**PLANNING DIVISION REPORT  
DEPARTMENT OF PLANNING AND COMMUNITY  
AND ECONOMIC DEVELOPMENT**

**RE: I.D. #11788: Zoning Map Amendment I.D. 3387, Rezoning of 1421 MacArthur Road from R1 to R2**

SUBJECT: 1421 MacArthur Road Rezoning

Figure 1: Existing lot widths for single family homes along the 1300 and 1400 blocks of Mac Arthur Road

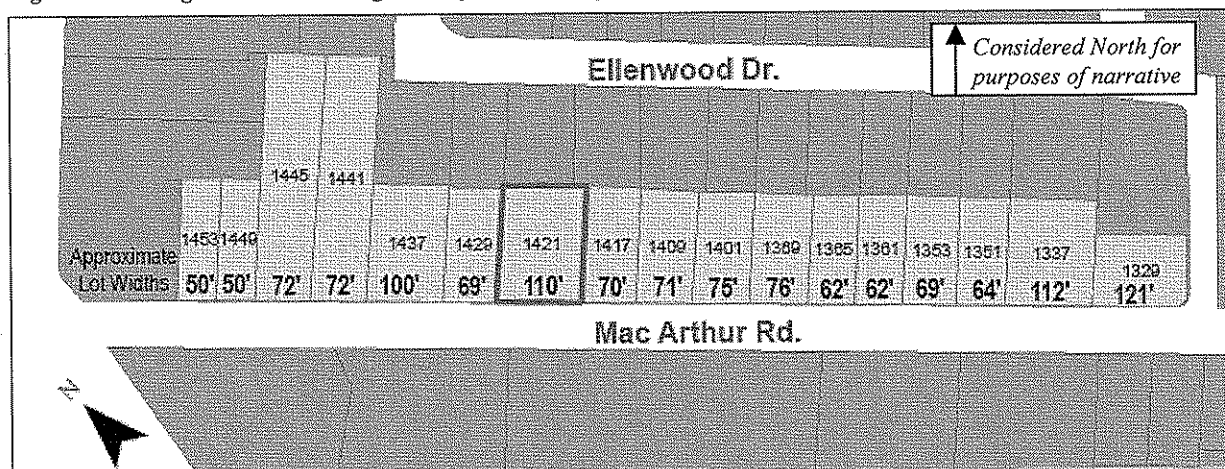
At approximately 110 feet wide, the subdivision of 1421 Mac Arthur Road would create two lots narrower than most of the others on the block. However, as long as a single-family home built on the new lot in the future generally conforms to others in the area, it might not significantly affect the rhythm of the block or the overall character of the neighborhood. Unfortunately, the applicant has not formally submitted a certified survey map or plans for a new single-family home for the Plan Commission to consider at this time. While indicating that they intend to construct an 800-1,200 square-foot home at some point in the future, it is difficult to assess the tangible impacts of the rezoning without knowing the dimensions of the new lot and exactly what is proposed on the new lot.
